UNITED STATES PATENT AND TRADEMARK OFFICE

APPLICATION NO.	FILING DATE	FIRST NAMED INVENTOR	ATTORNEY DOCKET NO.	CONFIRMATION NO.
10/539,922	08/09/2007	Eric Schliemann	05-431	8428
34704	7590	06/21/2010	EXAMINER	
BACHMAN & LAPOINTE, P.C. 900 CHAPEL STREET SUITE 1201 NEW HAVEN, CT 06510			LONG, DONNELL ALAN	
			ART UNIT	PAPER NUMBER
			3754	
			MAIL DATE	DELIVERY MODE
			06/21/2010	PAPER

Office Action Summary	Application No.	Applicant(s)	
	10/539,922	SCHLIEMANN, ERIC	
	Examiner	Art Unit	
	DONNELL LONG	3754

DETAILED ACTION

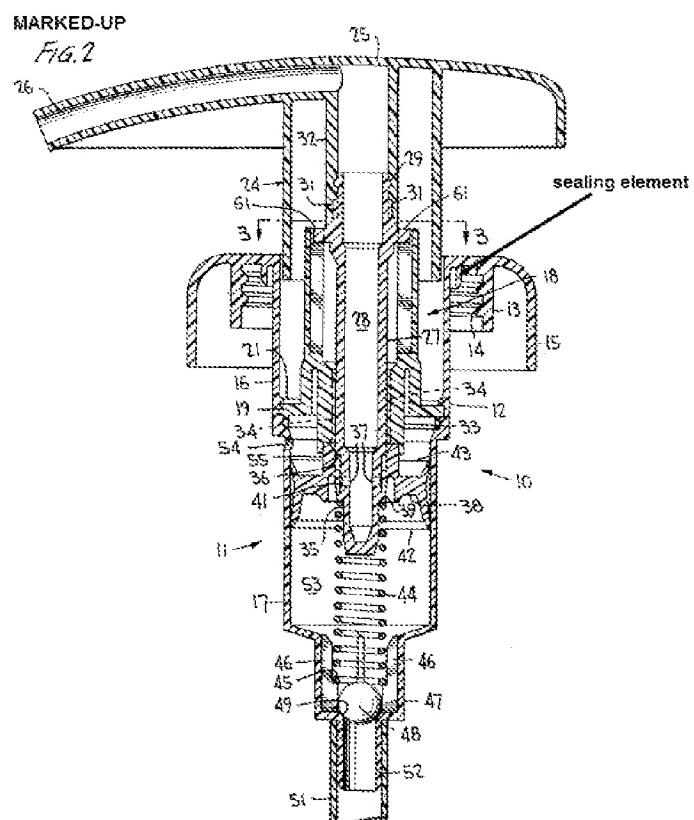
each other, a dosing and displacement chamber (53) provided between the inlet and duct, wherein the inlet and duct are closable by closure means (39, 41), the inlet and the chamber are disposed in a housing (12), the inlet opens out into the chamber (FIG. 2), the device includes a suction tube (51), an actuating element (25) is inserted in the housing in which the duct is provided, and an ascending tube (32) in the actuating element cooperates with the duct.

Regarding claim 42, a screw-type cap (Grothoff, 15) is disposed on the housing, wherein a central opening is provided for air equalization and a sealing element (marked-up Fig. 2) is disposed in the cap.
